APPLICATION NO.	FILING DATE	FIRST NAMED INVENTOR	ATTORNEY DOCKET NO.	CONFIRMATION NO.
10/790,583	03/01/2004	David Wiekhorst	65823-0540	9881
23552	7590	10/05/2005		
MERCHANT & GOULD PC P.O. BOX 2903 MINNEAPOLIS, MN 55402-0903			EXAMINER LEE, JINHEE J	
			ART UNIT 2831	PAPER NUMBER

Office Action Summary

Serial No. 10/790,583
Reply to Office Action of April 5, 2005
Replacement Sheet for Fig. 6

FIG. 6

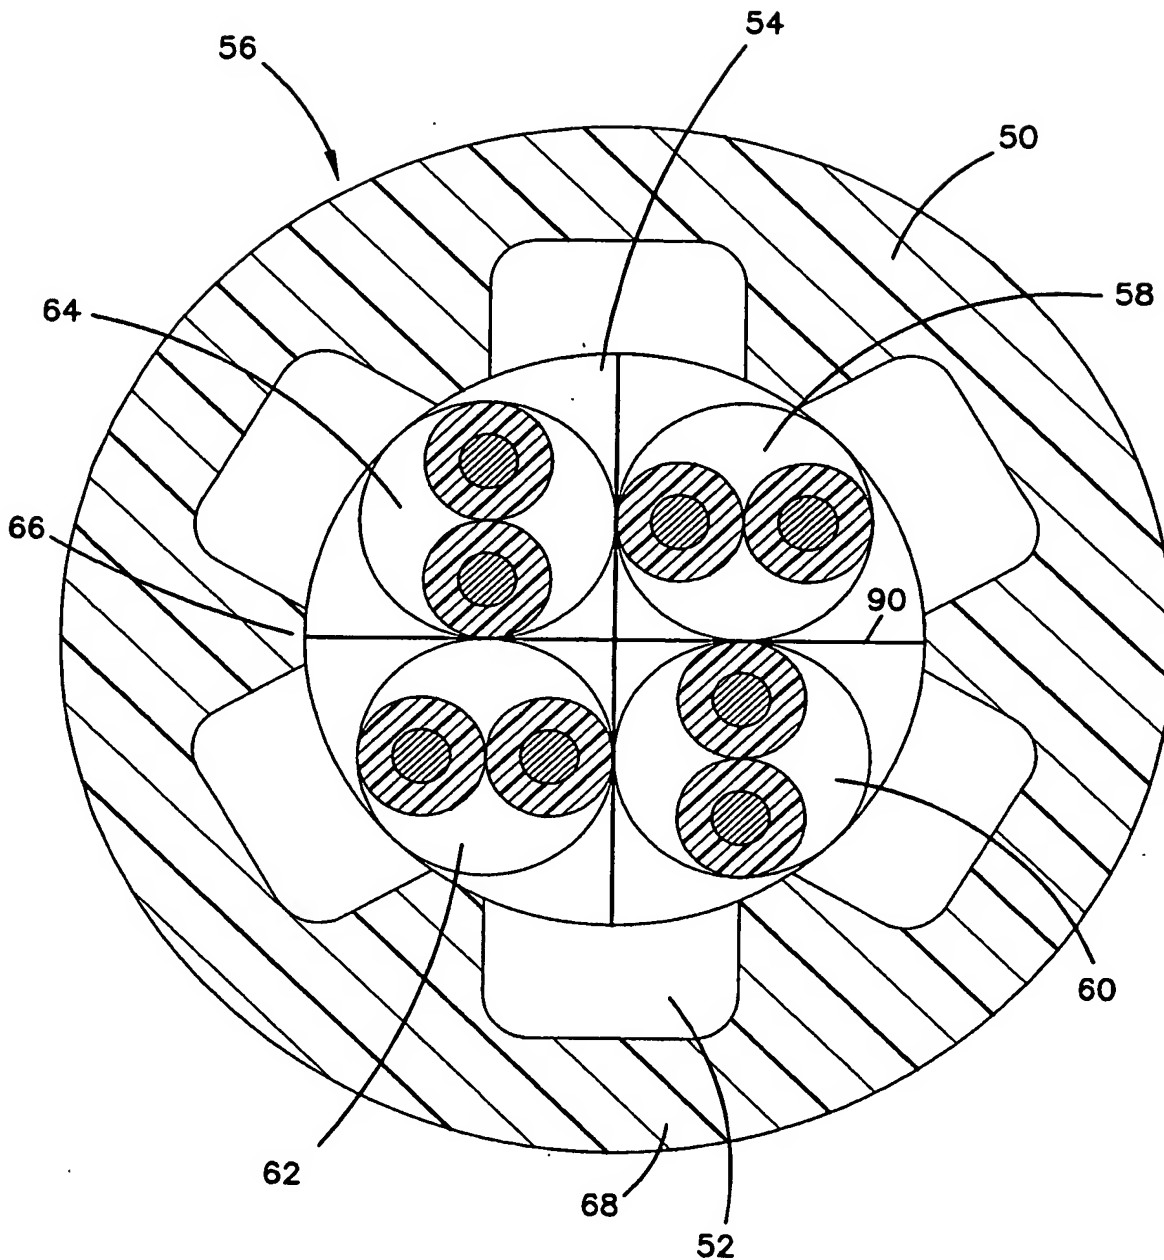
Separator 90 on replacement figure 6 is new matter and was not previously disclosed in such a way as to reasonably convey to one skilled in the relevant art that the inventor(s), at the time the application was filed, had possession of the claimed invention. Applicant is required to cancel the new matter.

Not Approved 9/22/05

FIG. 7

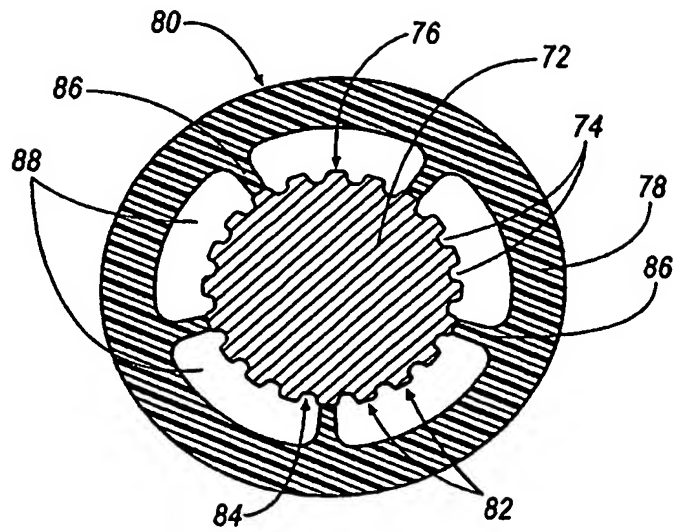
Not Approved *[Signature]* 9/24/05
